UNITED STATES PATENT AND TRADEMARK OFFICE
CERTIFICATE OF CORRECTION

PATENT NO. : 6,867,645 B1
APPLICATION NO. : 09/937680
DATED : March 15, 2005
INVENTOR(S) : Ansari et al.

(54) **METHOD AND APPARATUS FOR PROVIDING PULSE WIDTH MODULATION**

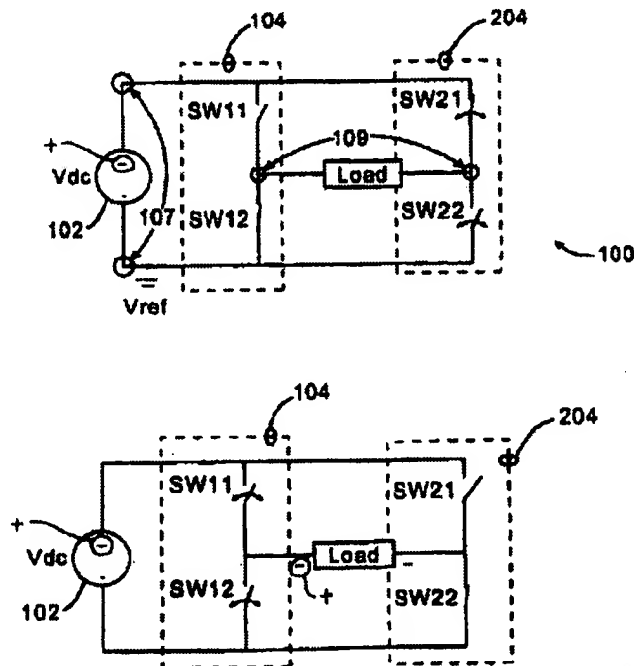
On the title page and in FIG. 1, in the power supply 102, delete the upper “-” sign and insert -- + --.

On the title page and in FIG. 3, in the power supply 102, delete the upper “-” sign and insert -- + --; and to the left of the “LOAD” box, delete the “-” sign and insert -- + --.

FIG. 9

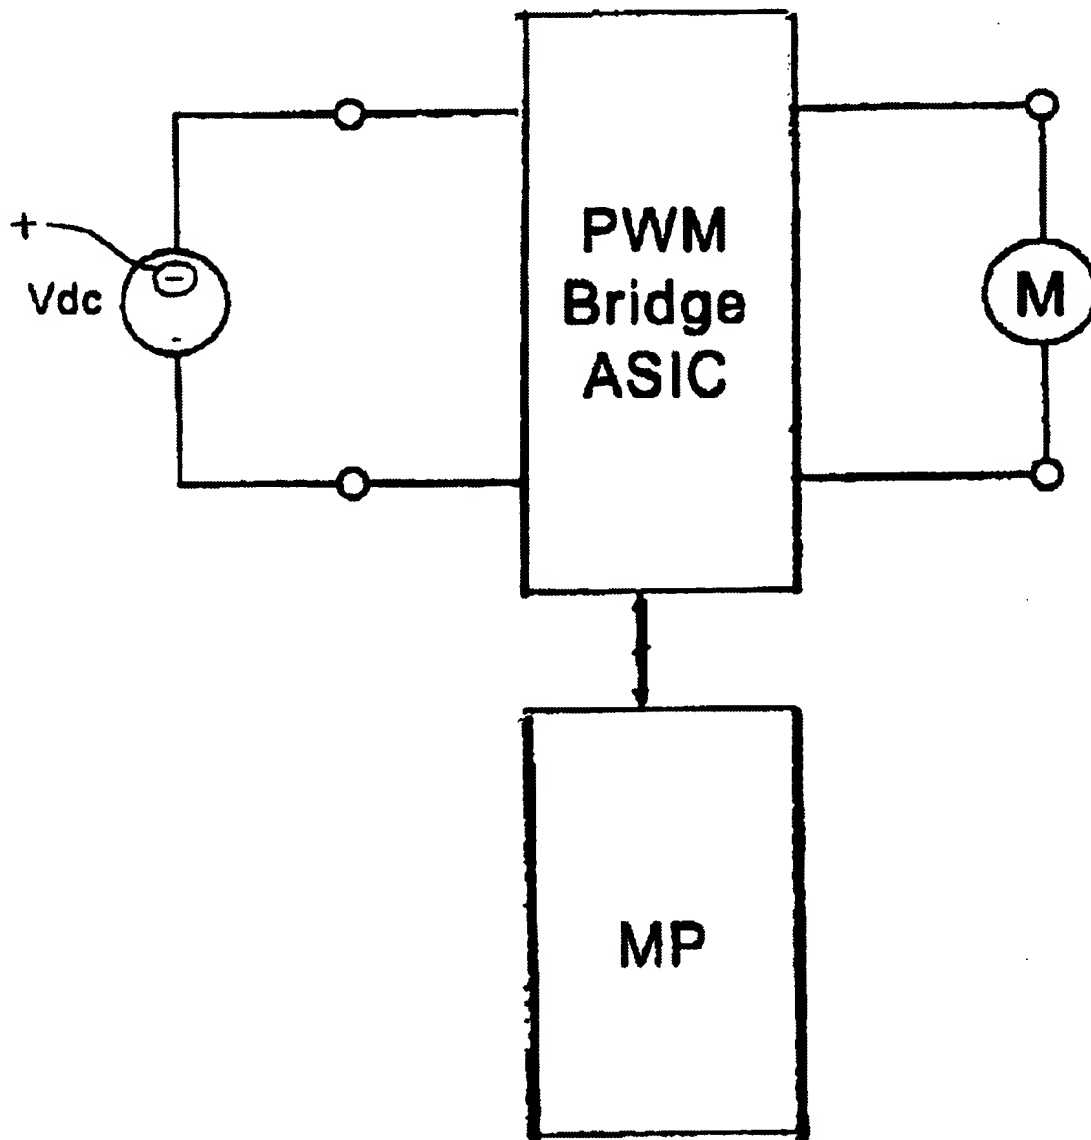
FIG. 9, at the “Vdc” location, delete the upper “-” sign and insert -- + --.
